APPLICATION NO.	FILING DATE	FIRST NAMED INVENTOR	ATTORNEY DOCKET NO.	CONFIRMATION NO.
10/692,326	10/22/2003	Dean Foote	LAMA121883	8551
26389 7590 03/07/2007 CHRISTENSEN, O'CONNOR, JOHNSON, KINDNESS, PLLC 1420 FIFTH AVENUE SUITE 2800 SEATTLE, WA 98101-2347			EXAMINER	
			PATEL, VISHAL A	
			ART UNIT	PAPER NUMBER
			3673	
SHORTENED STATUTOR	Y PERIOD OF RESPONSE	MAIL DATE	DELIVERY MODE	
3 MONTHS		03/07/2007	PAPER

Application No.	Applicant(s)				
	10/692,326	FOOTE ET AL.				
Office Action Summary	Examiner	Art Unit				
	Vishal Patel	3673				
The MAILING DATE of this communication appears on the cover sheet with the correspondence address Period for Reply						
A SHORTENED STATUTORY PERIOD FOR REPLY WHICHEVER IS LONGER, FROM THE MAILING DA - Extensions of time may be available under the provisions of 37 CFR 1.13 after SIX (6) MONTHS from the mailing date of this communication. - If NO period for reply is specified above, the maximum statutory period w - Failure to reply within the set or extended period for reply will, by statute, Any reply received by the Office later than three months after the mailing earned patent term adjustment. See 37 CFR 1.704(b).	ATE OF THIS COMMUNICATION 36(a)

F16.2, US: 4,877,217

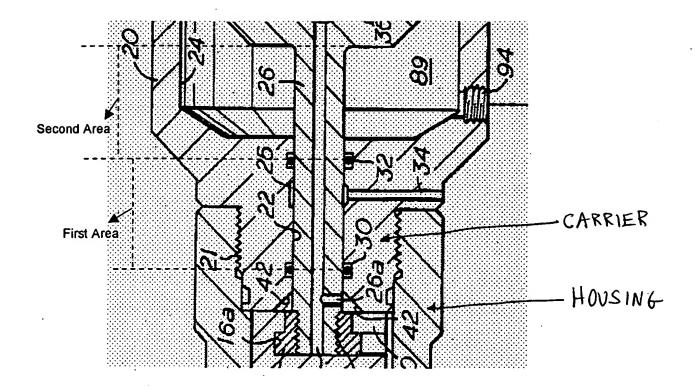
Peil discloses a seal assembly for a reciprocating shaft (intended use) comprising a body having a bore (bore 22), a shaft (shaft 26) that moves reciprocally within the body between an extended position from the body and a retracted position within the body (shaft 26 reciprocates), at least one first circumferential seal (seal 30 seals the shaft) positioned in the body and circumscribing the shaft, the first circumferential seal performing a dedicated seal function of preventing fluids from migrating along the shaft from a first region of the body, the shaft having a first seal travel area (seal area that is contacted by first seal 30) which is in contact with the first seal during axial reciprocating movement of the shaft (portion that contacts as seen in figures 2-3), at least a portion of the first seal travel area extending from the body where it is exposed to contaminants when the shaft is in the extended position (intended use), at least one second circumferential seal (seal 32) positioned in the body and circumscribing the shaft in axially spaced relation to the first circumferential seal (seal 30), the second circumferential seal being dedicated to performing the same sealing function as the first circumferential seal (the seal 32 is capable of sealing the shaft in an event the first seal fails) and serving as a redundant back up

seal until the first circumferential seal experiences seal failure (intended use when the first seal fails, but the seal 32 is a redundant seal for preventing fluid from entering the second region), the second circumferential seal being positioned to prevent fluid from migrating along the shaft from the first region of the body and to maintain the seal at the first end of the shaft in the event of a failure of the first circumferential seal (intended use when the first seal fails and a resultant would occur, the second seal 32 is a redundant seal for the first seal 30), the shaft having a second seal travel area (area of the shaft 26 that only contacts seal 32) which is in contact with the second seal during axial reciprocating movement of the shaft the second seal area remaining sheltered within the body even when the shaft is in the extended position (the second seal area is sheltered in the body, see figures 1-3), the first seal travel area and the second seal travel area being axially spaced separate and distinct areas on the shaft (the first seal travel area is distinct from the second seal travel area), such that damage to the exposed portion of the first seal travel area leading to a failure of the at least one first circumferential seal does not lead to failure of the at least one second circumferential seal, as the second circumferential seal engages the second seal travel area which is separate and distinct from the first seal travel area (as seen in figures 2-3, an outer surface of the shaft 26 between seals 30 and 32 is smaller than the outer surface of the shaft 26 between the second seal 32 and end of 36, see attached figure).

The seal including a seal cluster having a primary seal and a seal carrier (carrier as shown in attached figure 2 and primary seal 30 and 32).

shaft, which is taught by Peil. Furthermore the seals 30 and 32 are preventing fluid from migrating toward 71.
